FIRE STATION CONSTRUCTION AINKAWA, IRAQ

SIGIR PA-06-036
APRIL 12, 2006

SUBJECT: Report on Project Assessment of the Fire Station Construction, Ainkawa,
Iraq (Report Number SIGIR-PA-06-036)

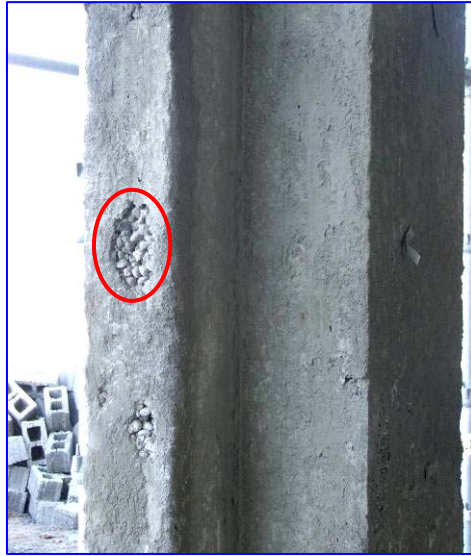
The task order specifications for concrete required the use of naturally occurring sand and crushed gravel, uniformly graded. The aggregate utilized in the reinforced concrete shown in Site Photos 5-9 appears to be rounded, uncrushed gravel.

Site Photo 4. Honeycombing/exposed reinforcing steel in concrete column on Level 1 - Photo provided by USACE.

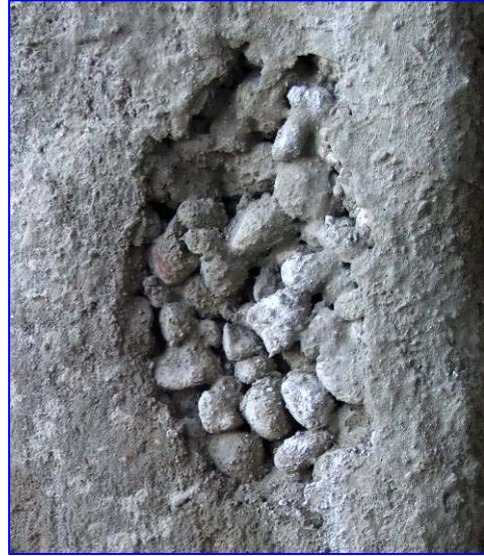
The USACE RE informed us there is a serious issue with the quality and possible structural integrity of the reinforced concrete shear walls, columns and beams located in Level 1. Parsons constructed these structural members in Level 1 in early May 2005. There were considerable voids in the reinforced concrete on this level, particularly in the columns. The first three meters of the columns contain significant honeycombing³ resulting from improper placement and poor vibration of the concrete. The contractor batched the concrete onsite utilizing a small drum mixer (less than 1 cubic meter (m³) in size). The mixer produced one small batch at a time without proper controls in place to assure the same mix ratio was utilized for every batch. The process used by the contractor to fill the forms with concrete was similar to a "fire brigade," where buckets of concrete were passed down a line of workers, up a ladder and poured into the form from the top. By pouring the concrete from the top of the forms, vibrators could not reach the bottom. As a result, the concrete could not be uniformly distributed, especially in the lower areas of the column or wall. Site Photos 4-8 show honeycombing found in columns in Levels 1 and 2 after concrete placement.
